Millstone Nuclear Power Station, Unit No. 2
 Request for Additional Information on IE Bulletin 80-11
Masonry Wall Design

Request for Additional Information

Masonry Wall Design

WALLS # 8.29, 8.22, 8.31

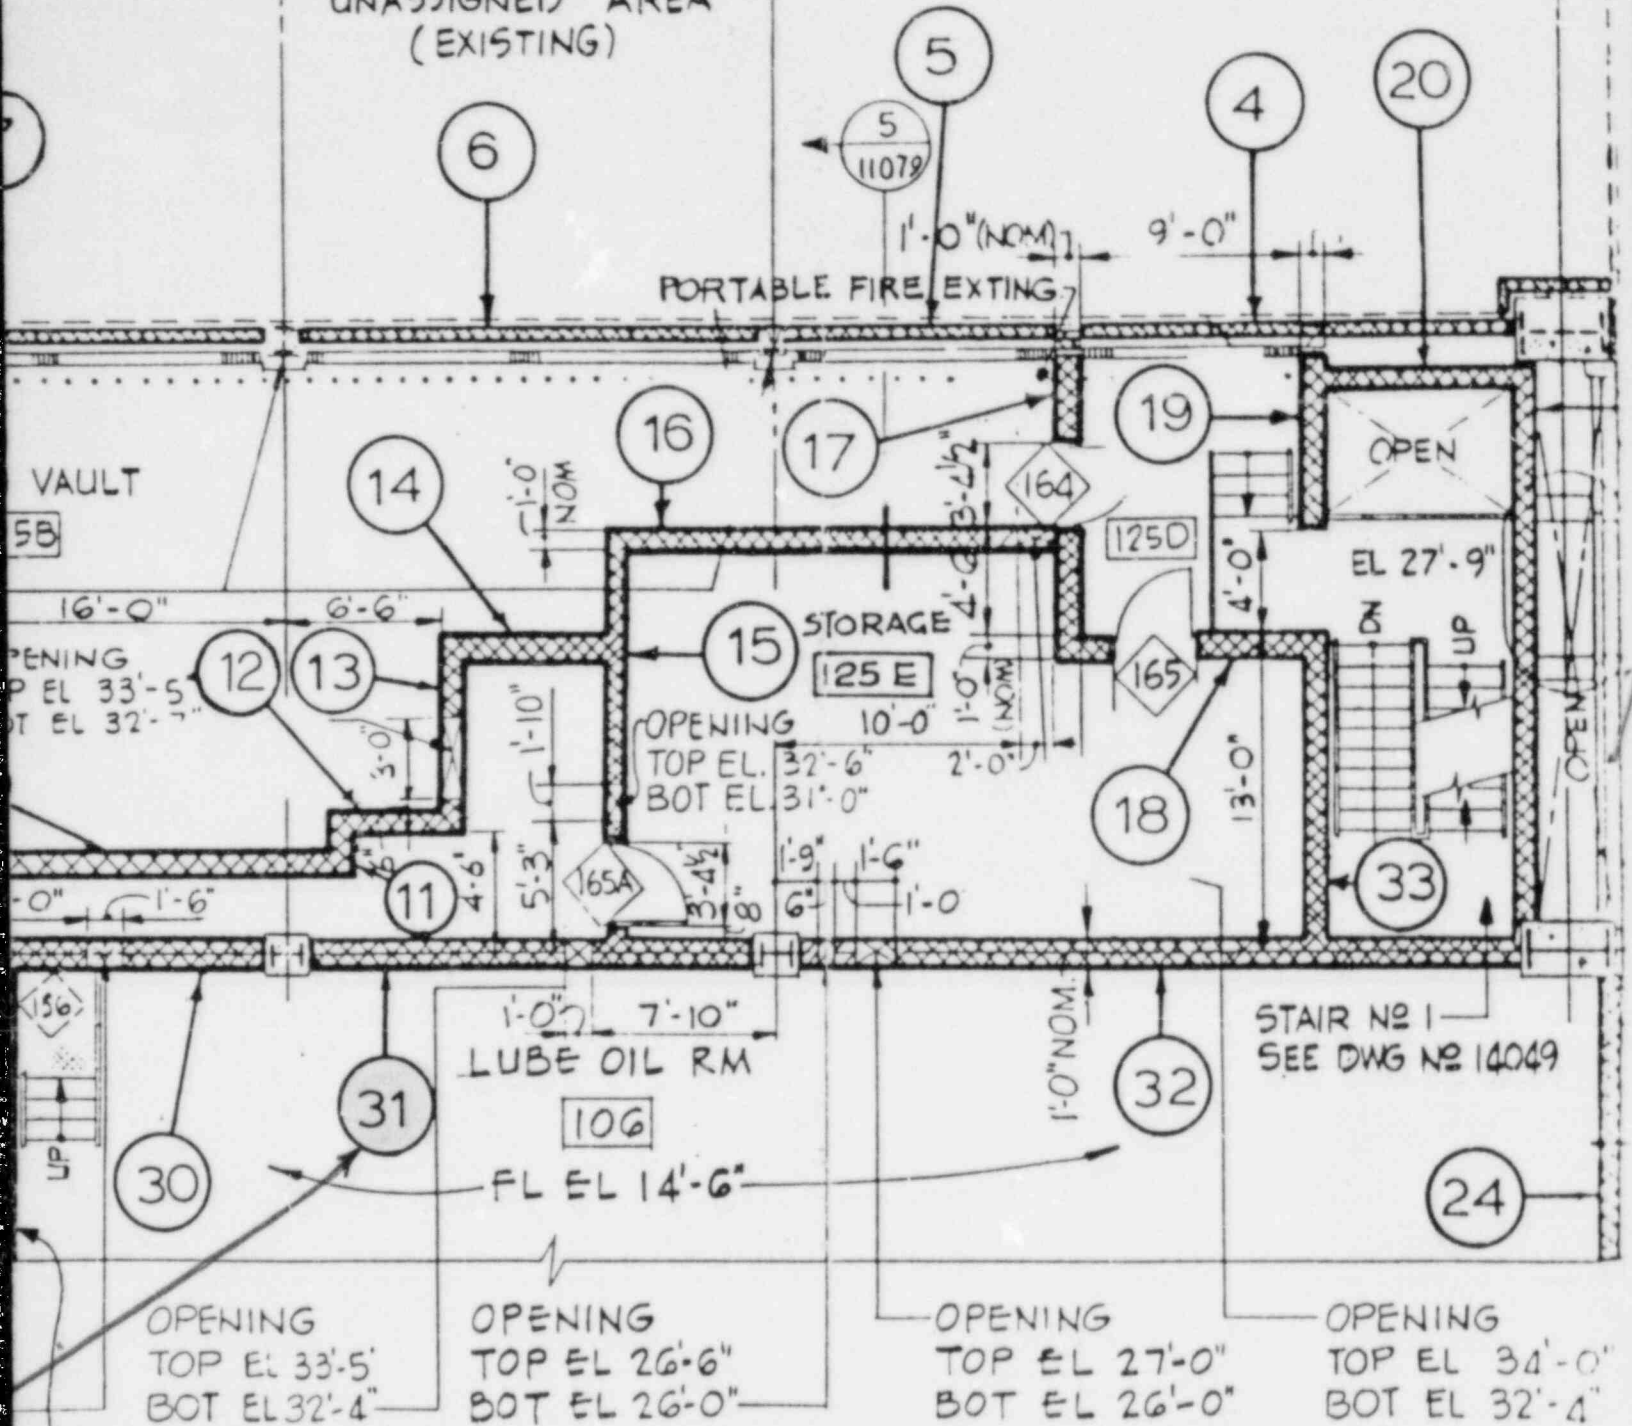
With respect to tornado load (2), specify all walls subject to tornado load (if applicable) and provide a sample calculation (with any explanation necessary to make it understandable). Also, indicate how the penetration depth, perforation, and spalling along with the overall structural behavior of the wall were evaluated for a tornado missile impact.

Even though localized impact, as well as penetration effects of missiles, were evaluated as part of the original design calculations of the plant, these effects are of low probability due to the physical locations of the wall, in question. Five of the ten walls evaluated for tornado loads are interior walls (Attachment 3). This would mean that a wall outside of the wall in question would have to be blown away before the interior wall could be impacted. The five exterior walls are located at elevations 25'-6" (8.22, 8.29, and 8.31) and 54'-6" (6.1 and 6.2). The Standard Review Plan (SRP), Section 3.5.1.4, states that the utility pole and automobile missiles need only be considered at elevations up to 30 feet above site grade. The four remaining missiles described in the SRP are the wood plank, the 6-inch schedule 40 pipe, the 1-inch steel rod, and the 12-inch schedule 40 pipe. Because walls 6.1 and 6.2 are located at such a high elevation (40 feet above site grade), it is unlikely a missile would reach that elevation and still retain sufficient force to penetrate the wall. Walls 8.22, 8.29, and 8.31 are located in the cable vault area which is protected on the north side by the turbine building (Attachment 4). All of the walls that were evaluated for tornado loads are reinforced and have adequate boundary conditions.

In summary, all of the walls listed in the May 11, 1984 submittal as being subjected to tornado loads were designed to withstand a 360 mph wind load as well as a 3 psi depressurization load as shown in the calculations. The auxiliary and turbine buildings at Millstone Unit No. 2 were considered to resist wind and tornado loads according to Section 5.4.3.1.6 of the FSAR and the design wind

pressure is in accordance with the ASCE Paper 3269, "Wind Forces on Structures." These walls were also evaluated for localized impact as well as penetration effects from missiles even though the scenario is not credible. Due to the location of exterior walls, it has been determined that the overall structural behavior due to tornado missile impact, as defined in the Standard Review Plan, Section 3.5, need not be evaluated.
